CONTRACT CHANGE ORDER NO. 37S01
SHEET 3 OF 11

SAN FRANCISCO OAKLAND BAY BRIDGE
EAST SPAN SEISMIC SAFETY PROJECT
SELF-ANCHORED SUSPENSION BRIDGE
(SUPERSTRUCTURE & TOWER)

MARK	DATE	DESCRIPTIONS	BY	CH'D	CCO#
1	01/28/11	MISCELLANEOUS CABLE SYSTEM DETAILS	GB	MN	37S1

SUSPENDER BRACKET DETAILS NO. 5

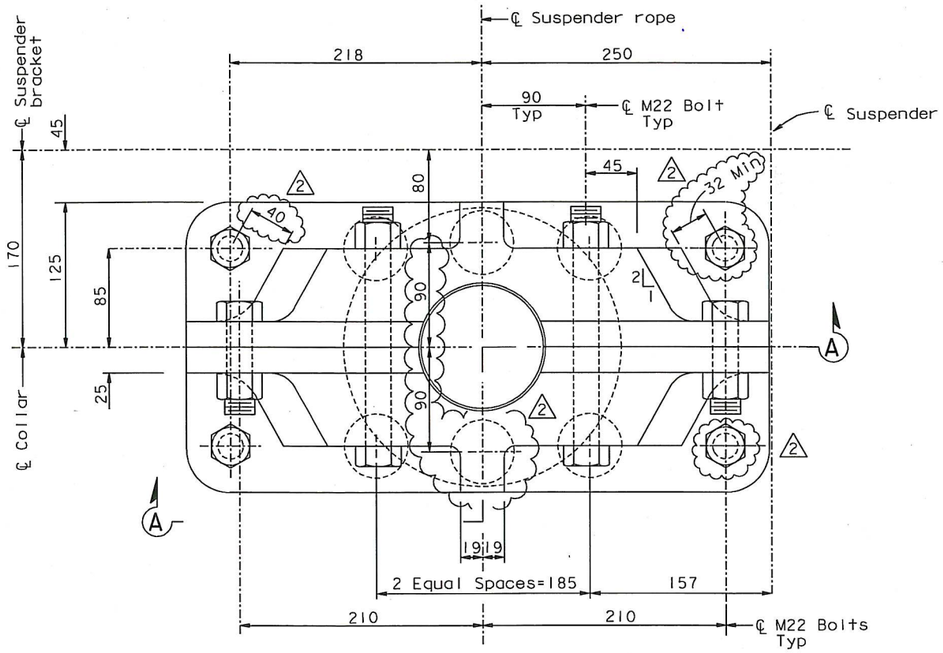
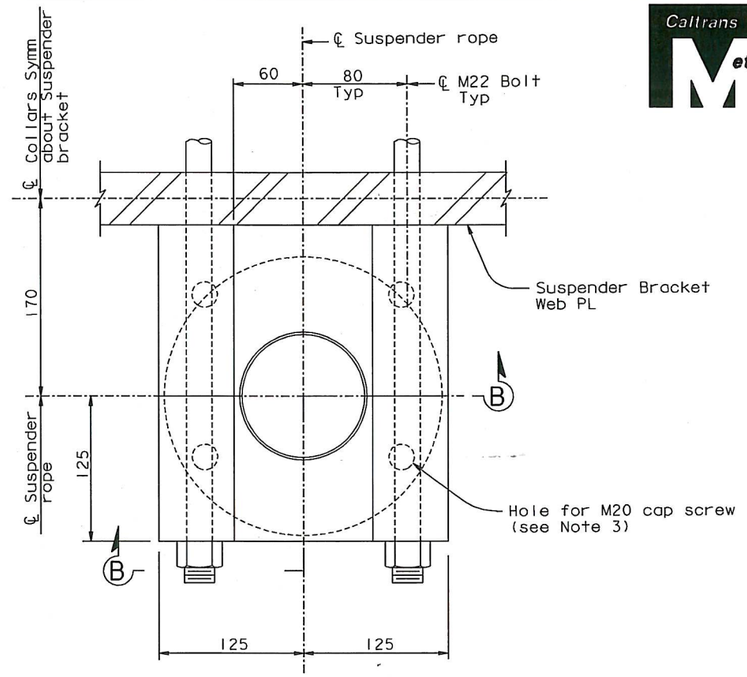
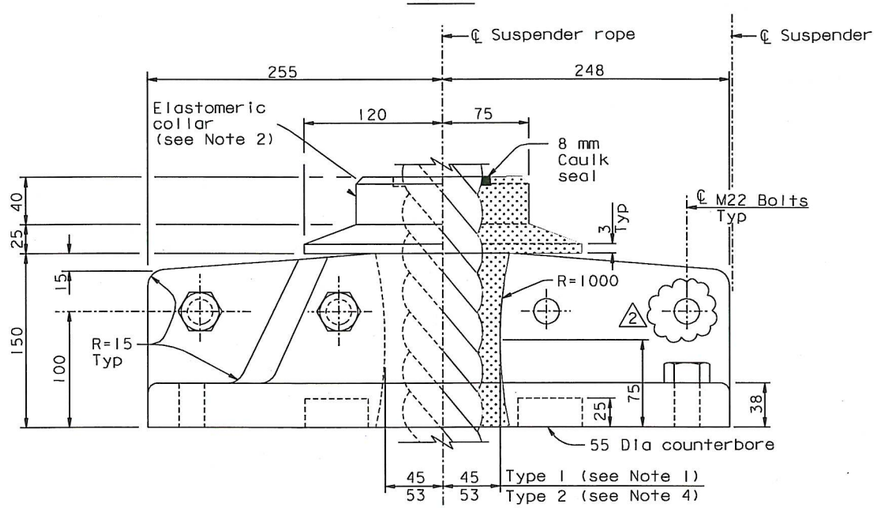
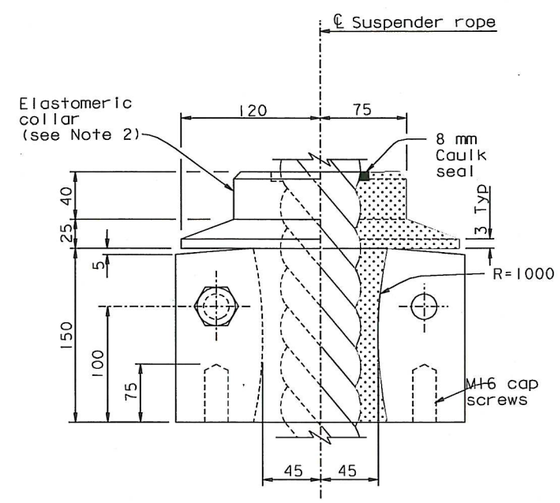
MARK	DATE	DESCRIPTIONS	BY	CH'D	CCO#
2	02/18/11	MISCELLANEOUS CABLE SYSTEM DETAILS	GB	DT	37S1
1	04/16/07	CABLE SYSTEM	GB	DT	37

CABLE BAND DETAILS NO. 4

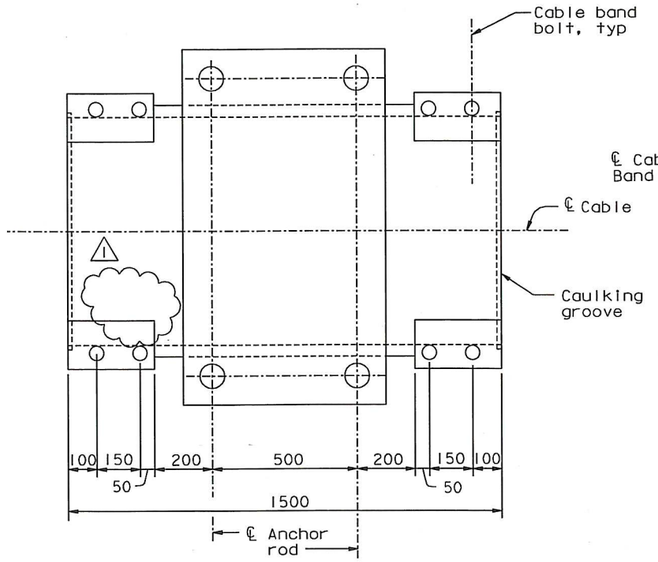
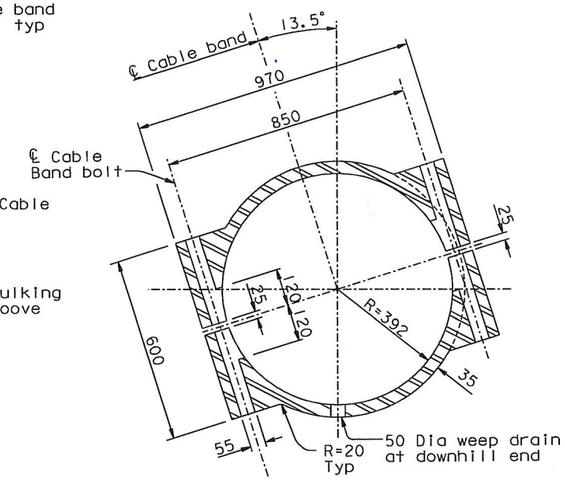
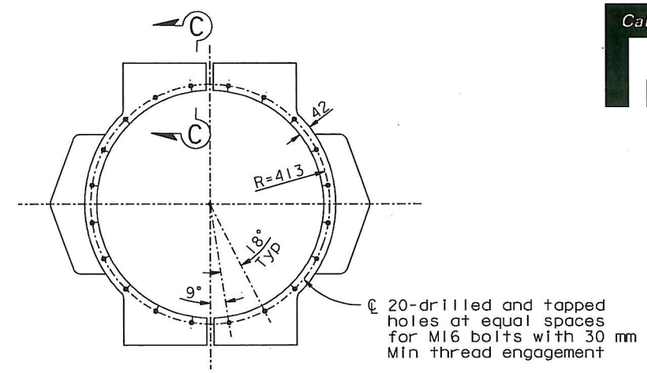
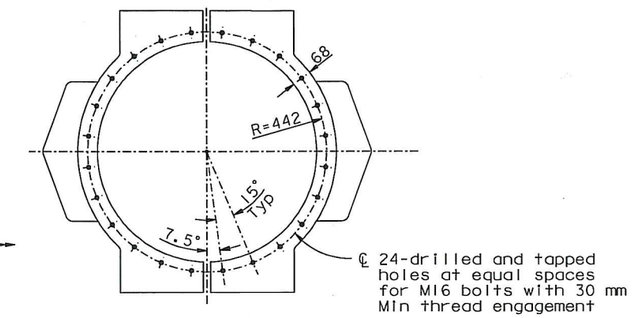
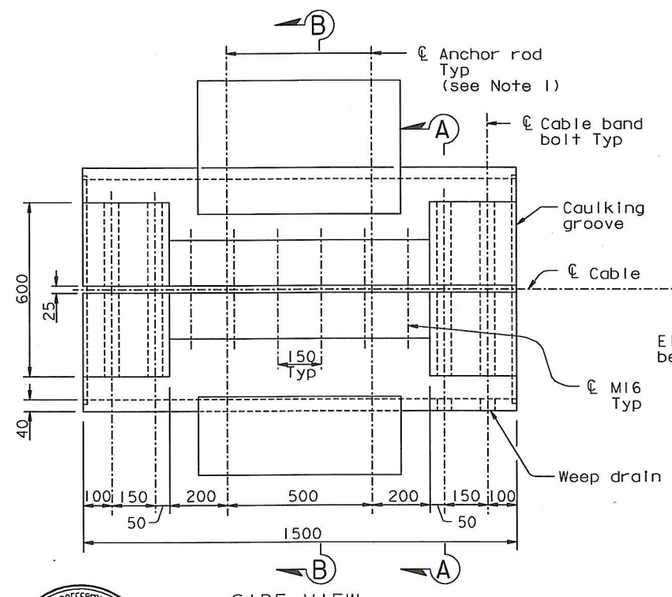
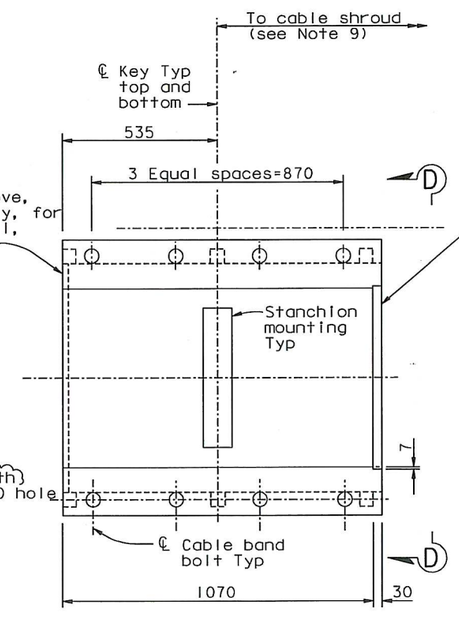
MARK	DATE	DESCRIPTIONS	BY	CH'D	CCO#
1	02/18/11	MISCELLANEOUS CABLE SYSTEM DETAILS	GB	MN	37S1

WEST ANCHORAGE ACCESS DETAILS NO. 3

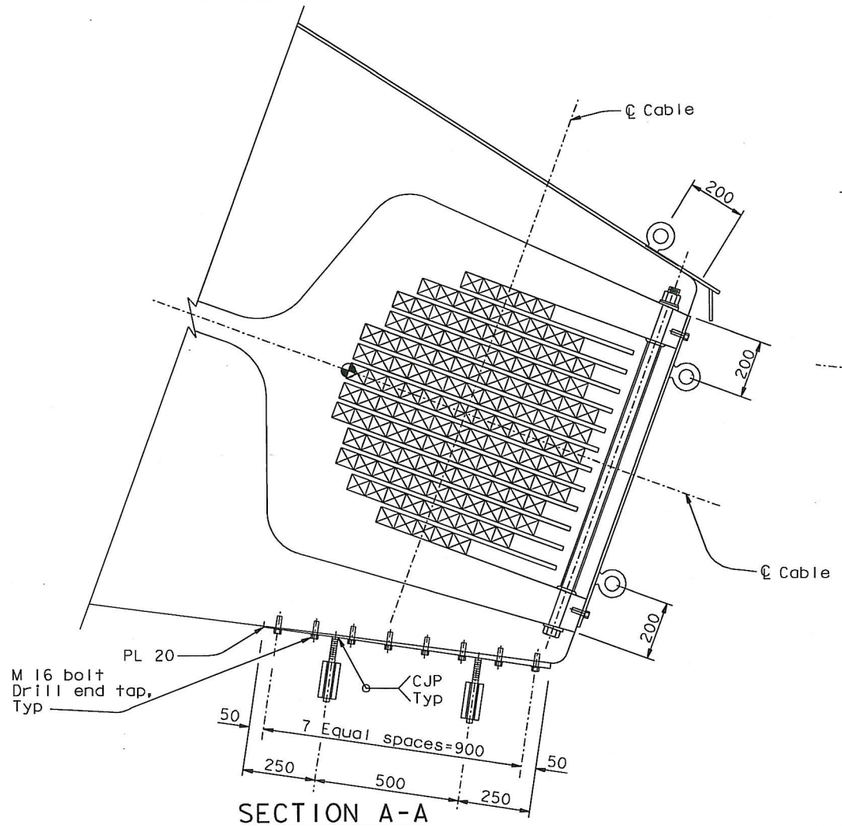
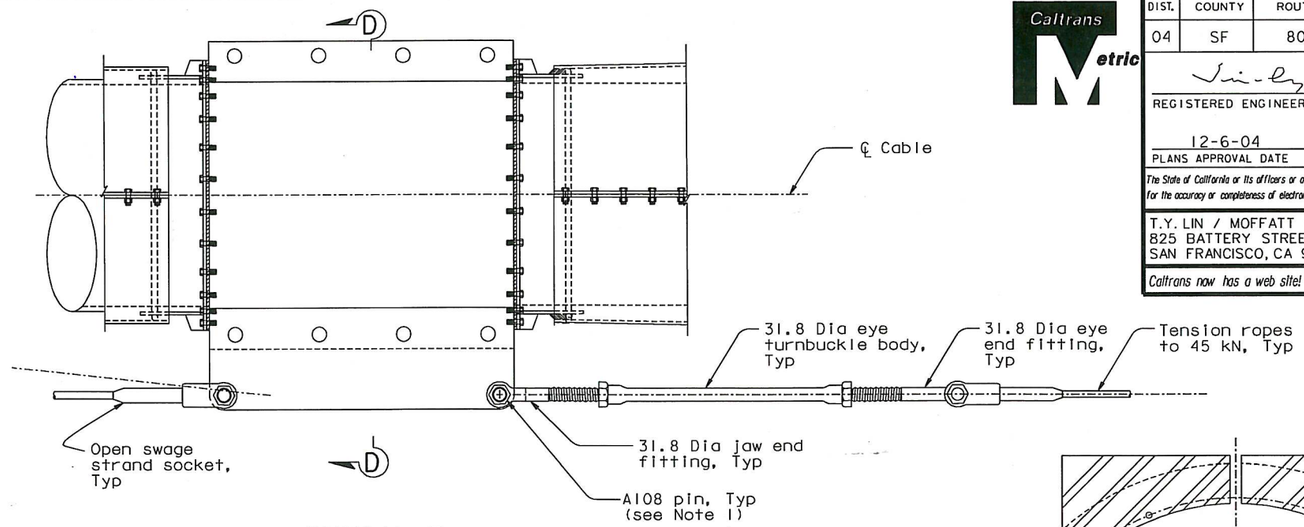
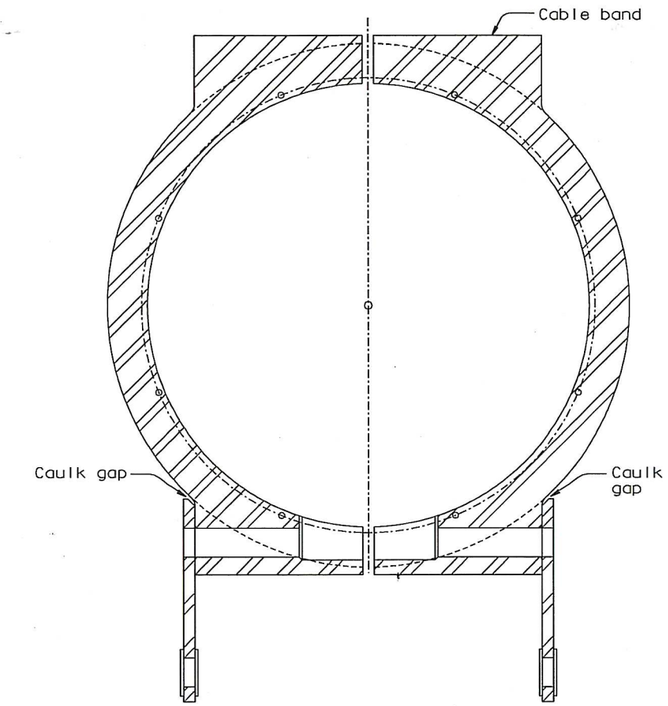
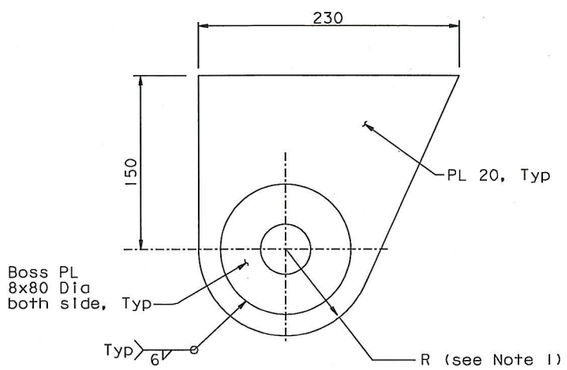
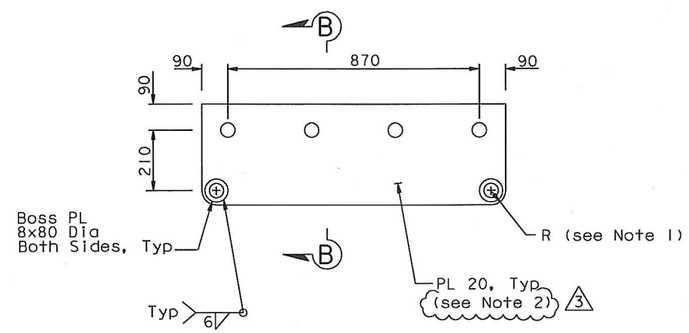
MARK	DATE	DESCRIPTIONS	BY	CH'D	CCO#
3	02/18/11	MISCELLANEOUS CABLE SYSTEM DETAILS	TH	GB	37S1
2	06/22/07	WELDED PADEYES	NV	TH	41
1	04/20/07	WEST ANCHORAGE ACCESS DETAILS	GB	TH	28

1. For pin details see "Cable Handrope Details No. 2" sheet.
2. (3) At the Contractor's option, 36 mm assembly plates without boss plates and with longer cable band bolts may be used in lieu of the detail shown, subject to review and approval of the Engineer.
